SOAH DOCKET NO. 473-21-0247
PUC DOCKET NO. 51023

APPLICATION OF THE CITY OF § BEFORE THE STATE OFFICE
SAN ANTONIO TO AMEND ITS §
CERTIFICATE OF CONVENIENCE § OF
AND NECESSITY FOR THE §
SCENIC LOOP 138-KV TRANSMISSION § ADMINISTRATIVE HEARINGS
LINE IN BEXAR COUNTY §

**CPS ENERGY’S RESPONSE TO ANAQUA SPRINGS HOMEOWNERS’
ASSOCIATION’S THIRD REQUEST FOR INFORMATION**

Exhibit:

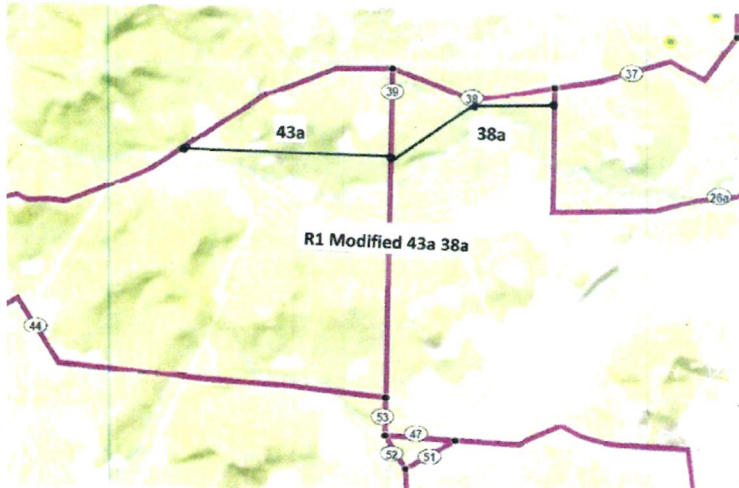
Please provide the cost, length, and habitable structure count on a modified Route R1 as follows: Substation 6, Segments 50, 15, 26a, 38 modified and renamed to 38a, and 43a, with modifications as shown on the attached exhibit.

“Modified and renamed” segments “43a” and “38a” as shown on the exhibit are not segments included in CPS Energy’s Application or Amended Application in this proceeding. CPS Energy has not identified, evaluated, or compiled data associated with these “modified” and “renamed” segments. Accordingly, CPS Energy does not have, and is therefore unable to provide, information responsive to this request.
